**SUBJECT:** NuScale Power, LLC Submittal of Changes to Tier 1 and Tier 2 of the NuScale Final Safety Analysis Report

**Enclosure 2:**

“Changes to NuScale Final Safety Analysis Report,” public

RAI 02.03.01-6, RAI 03.07.02-24S1, RAI 03.08.05-1, RAI 03.08.05-8

Figure 2.3-1: Limiting Analytical Distance to **Site-Owner-Controlled Area Fence** **EAB and LPZ** **Outer Boundary**

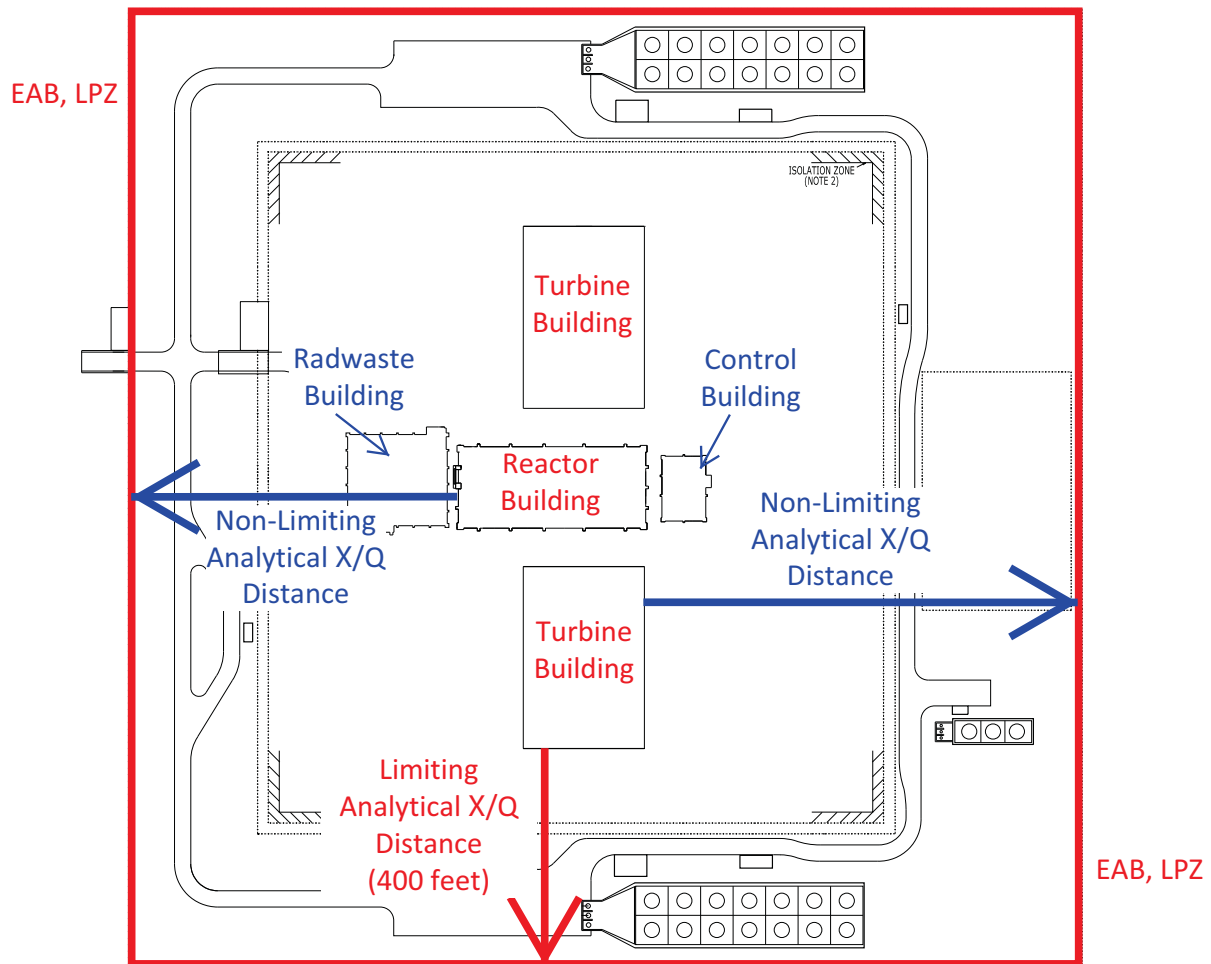
Atmospheric dispersion factors ( $\chi/Q$  values) are determined at ~~the site owner controlled area boundary. This fence is as close as 400 feet from the closest release point and may be used as both~~ the exclusion area boundary (EAB) and ~~as~~ the low population zone (LPZ) outer boundary, which may be as close as 400 feet from the closest release point. These  $\chi/Q$  values as well as the  $\chi/Q$  values for the MCR were determined for various sites in the United States using a meteorological database that included multiple years of data across all regions of the United States. This approach determined that the meteorological dataset for Sacramento, California, between 1984-1986, is representative of the bounding 80th to 90th percentile of potential NuScale Power Plant construction sites in the United States. This meteorological data set was used to calculate the  $\chi/Q$  values for the certified design.

The  $\chi/Q$  values at the ~~site owner controlled area fence~~ EAB and the LPZ outer boundary are listed in Table 2.0-1. These  $\chi/Q$  values are based on the source location and path shown in Figure 2.3-1.
